TECHNICAL BULLETIN	
	February 1996
	TB 1311
Mfg:	FORD
Model:	CAR & TRUCK
Liter:	5.0L
V I N:	F
Year:	88-93

Revised Cylinder Head Bolts & Installation Procedure On
Ford 5.0L Engines

Bulletin Diagram: Untitled Graphic #2140 for TB 01311

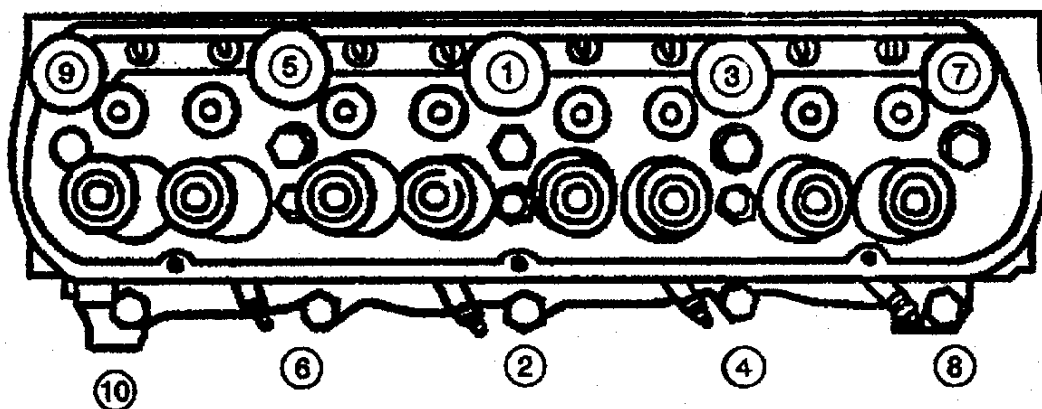
While the tightening sequence for both cylinder head bolt designs remain the same, the actual amount of torque applied is different (Figure 2). Follow the torquing procedures listed below to correctly install either style head bolt:

Step 1. Torque all bolts to 55 ft. lbs.
Step 2. Torque all bolts to 72 ft. lbs.
Step 3. Torque bolts 1,3,5,7 & 9 to 80 ft. lbs.

Torque all bolts to 25-35 ft. lbs.
Torque all bolts to 45-55 ft. lbs.
Turn all bolts an additional 85-95°

Bulletin Diagram: Untitled Graphic #2141 for TB 01311

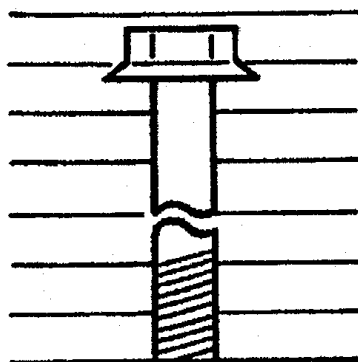
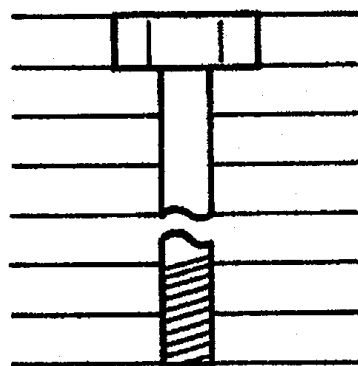
The AERA Technical Committee offers the following information on revised cylinder head bolts and installation procedure on Ford 5.0L engines. There are two styles of cylinder head bolts used on this engine. Starting with the 1992 model year, Ford used a torque-to-yield cylinder head bolt.

The torque-to-yield bolt can be easily distinguished from the former design by its flange as shown in figure 1 below.

Ford allows the use of either style bolt as long as they are used in complete sets. It is also recommended to replace torque-to-yield bolts, kit Part #F3ZZ-6065-E, every time the head is removed.
